Duke Power Company
Oconee Nuclear Station

UFSAR Chapter 15 Transient
Analysis Methodology

DPC-NE-3005-A
Revision 1

SUBJECT: OCONEE NUCLEAR STATION, UNITS 1, 2, AND 3 RE: SAFETY EVALUATION
FOR REVISION 1 TO TOPICAL REPORT DPC-NE-3005-P, "UFSAR
CHAPTER 15 TRANSIENT AND ACCIDENT ANALYSIS METHODOLOGY"
(TAC NOS. MA4713, MA4714, AND MA4715)

Figure 1

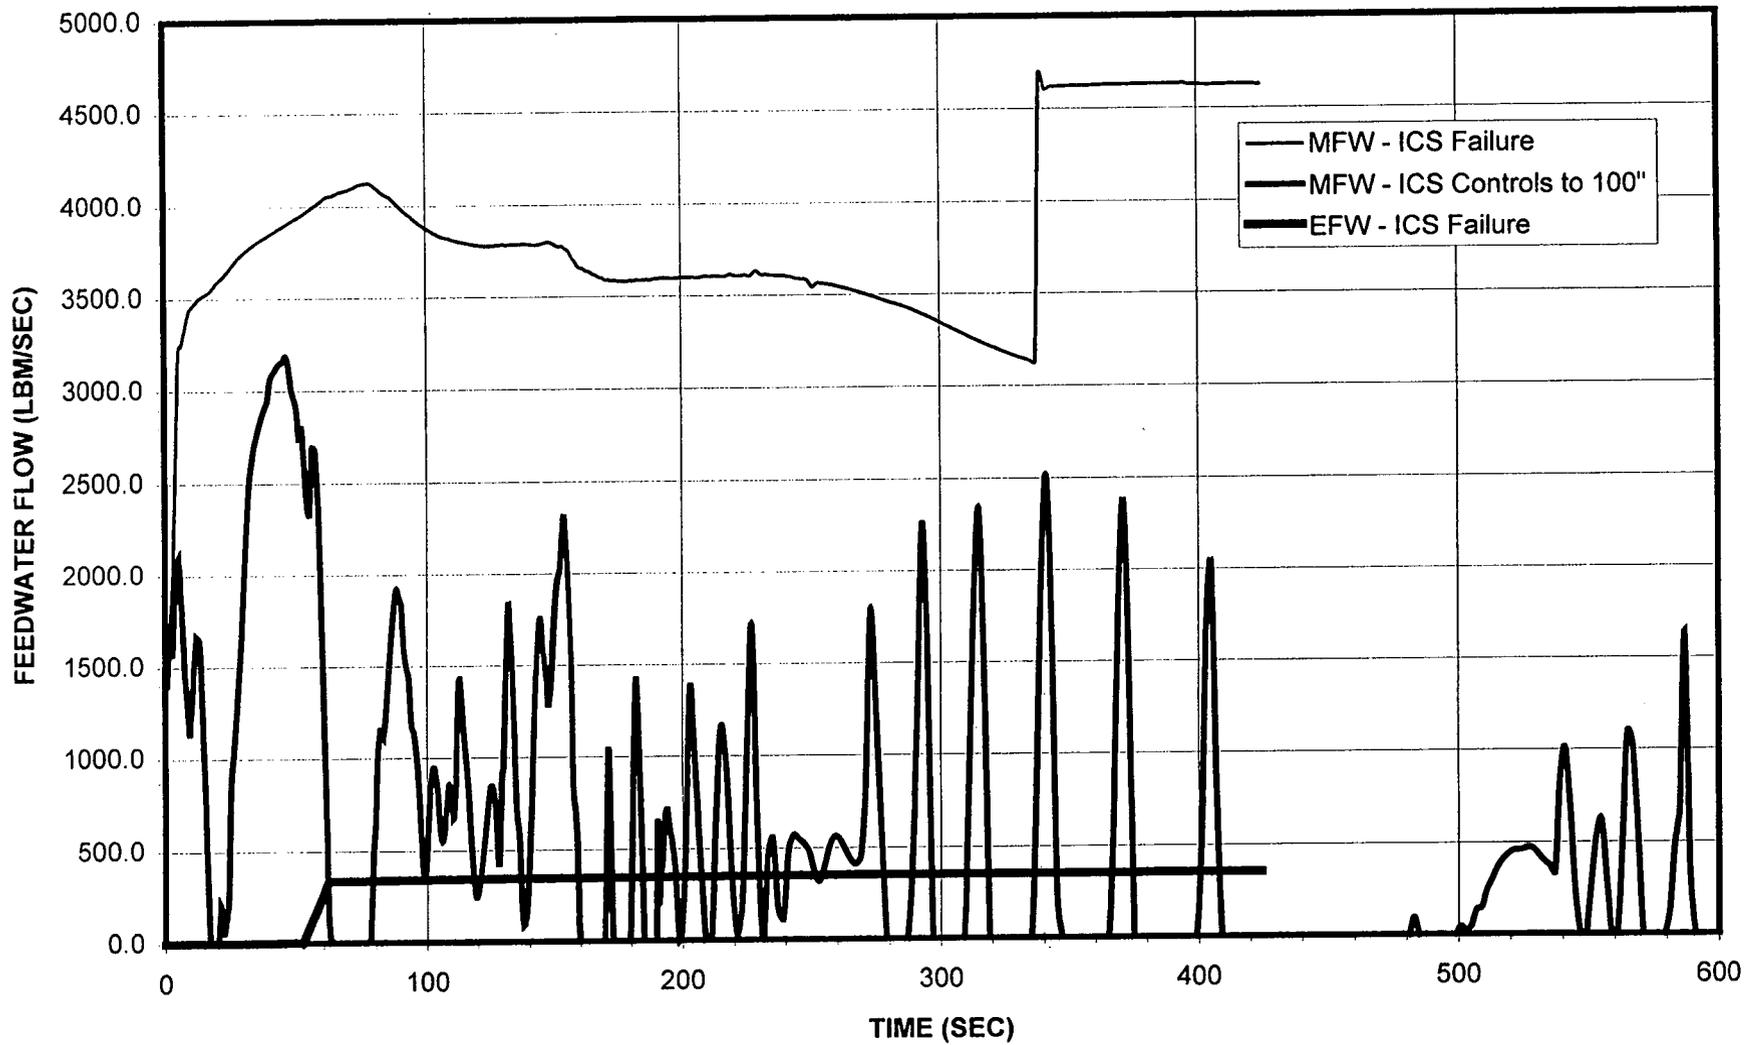
Figure 1 shows the feedwater flowrates to the affected steam generator. With the ICS controlling level to 100 inches, the MFW flow is throttled, whereas for the ICS failed both MFW and EFW flowrates are uncontrolled and much higher. Figure 2 shows the resulting steam generator level. With level control the level is approximately controlled to 100 inches, although the dynamic behavior of the transient causes instability in feedwater control and level response. Without level control the level continues to fill until going offscale at approximately 250 seconds. Figure 3 shows the steam generator liquid mass. With ICS level control the liquid mass is limited to 20,000-50,000 lbm, whereas the overfilled condition without ICS control reaches 180,000 lbm. The significant difference in the feedwater flow boundary condition for the two cases is evident.

Figure 4

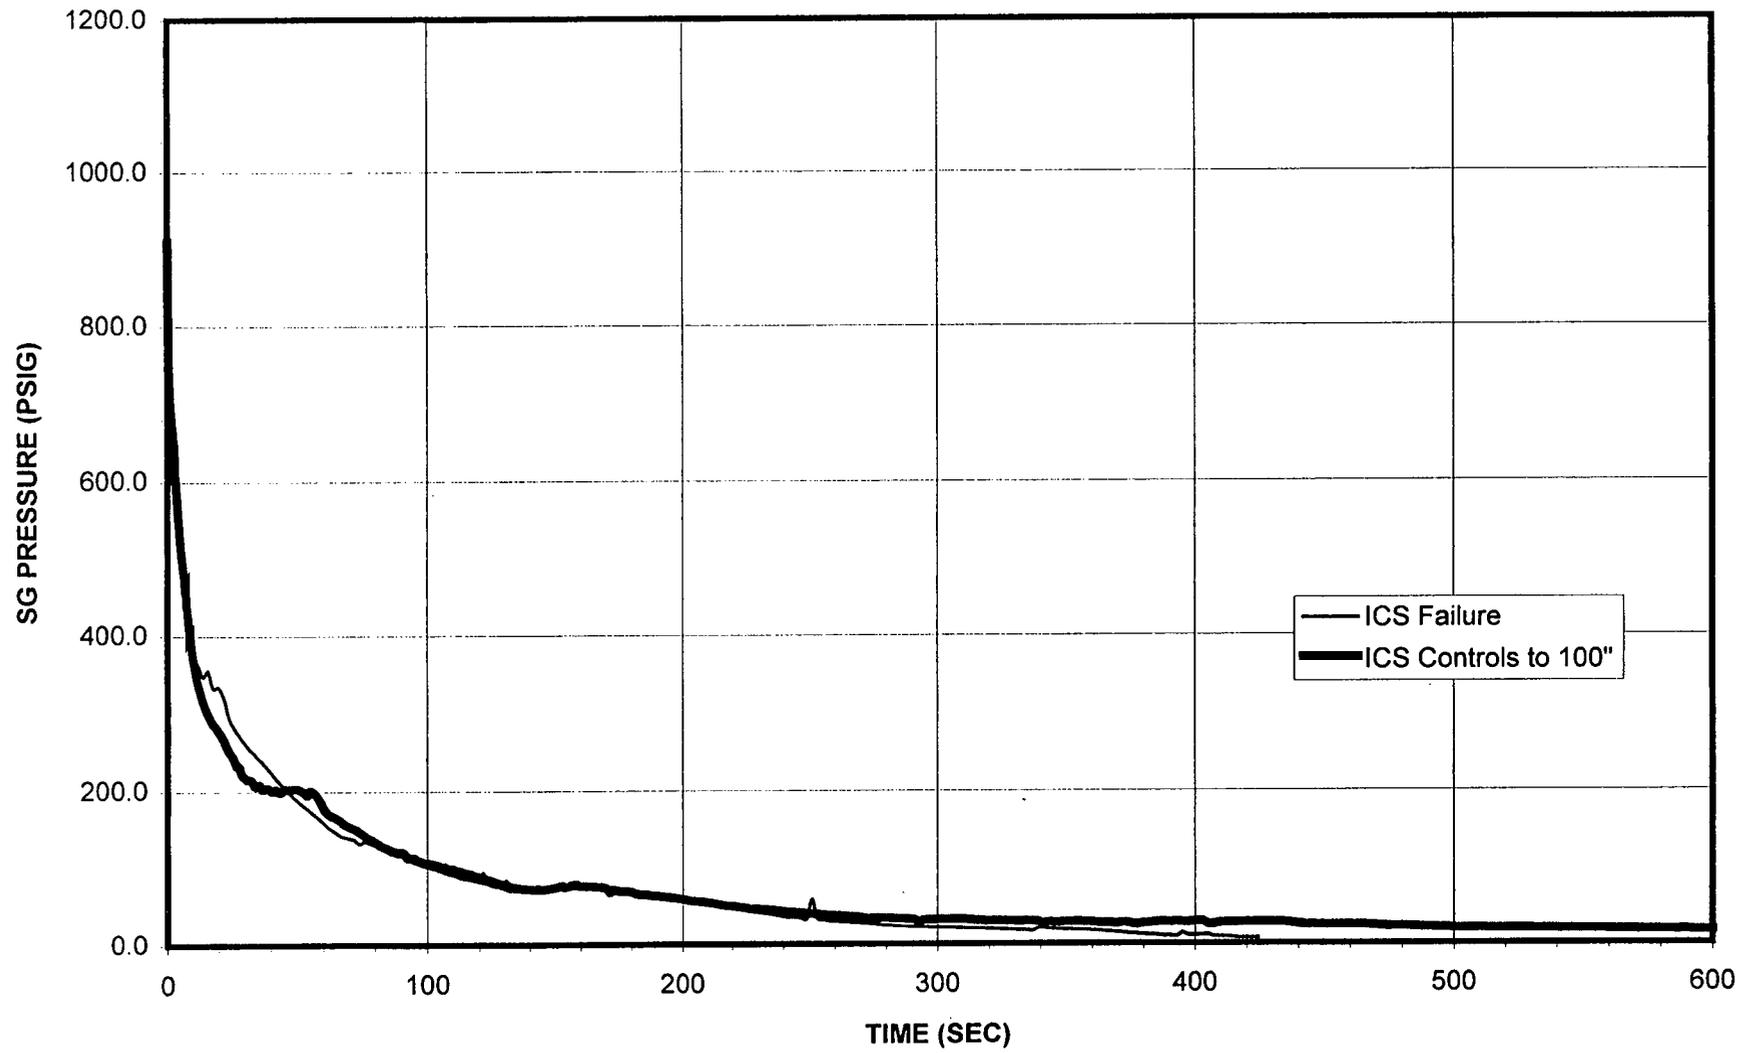
Figure 4 shows the comparison of the steam generator pressures at the top of the tube bundle. There is very little difference in these pressures, which indicates that the secondary saturation temperatures are similar. Figure 5 shows the comparison of the total heat transfer across the steam generator tubes. During the initial phase in which the steam generator is blowing down, the heat transfer rates are the same or similar. Then the case with ICS controlling level is somewhat higher in the period of 50-200 seconds. From 200-400 seconds the case without ICS control is somewhat higher. From Figures 1-5 it can be concluded that the higher feedwater flow without ICS control is offset by the lower heat transfer per lbm of feedwater, since much of the feedwater exits the steam generator in the liquid phase. Most of the feedwater in the case with the ICS controlling to 100 inches is boiled before exiting the steam generator, and therefore a higher heat transfer per lbm occurs. Figure 6 shows the core neutron power response. The case with ICS feedwater control peaks at 13.09% power at 160 seconds, and the case without ICS control peaks at 6.9% power. This occurs before the time period during which the case without ICS control experiences higher heat transfer.
